RE: Comment Response Letter – Site Development Plan – Discount Tire - Falcon (File #: PPR2112)

COMMENT RESPONSE LETTER

Site Development Plan

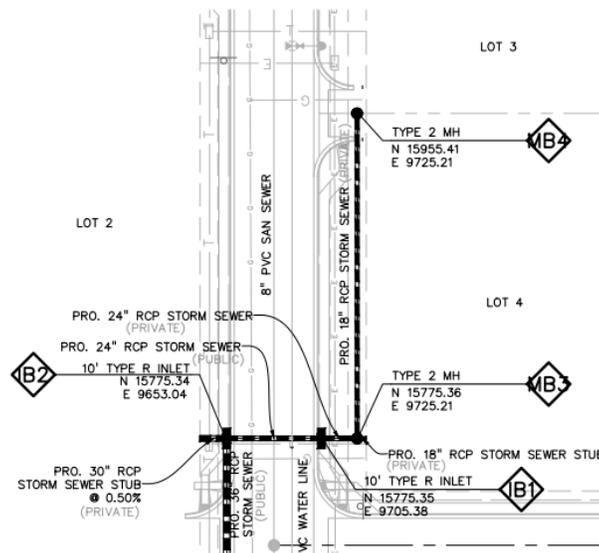
2. The approved drainage report for Falcon Marketplace indicates that a 24" RCP stub would be provided (page 10 of report). Also the approved CD's show a 24" stub. Was a 24" RCP not installed? Please address the discrepancy.

- *Response: The approved CD's dated 10/27/2020 show an 18" RCP stub on sheet C7.12. This was also confirmed by the ALTA survey performed on 12/10/2020. A snip from the plans is shown below. Our drainage analysis has concluded that the installed 18" stub will be adequate for the development.*
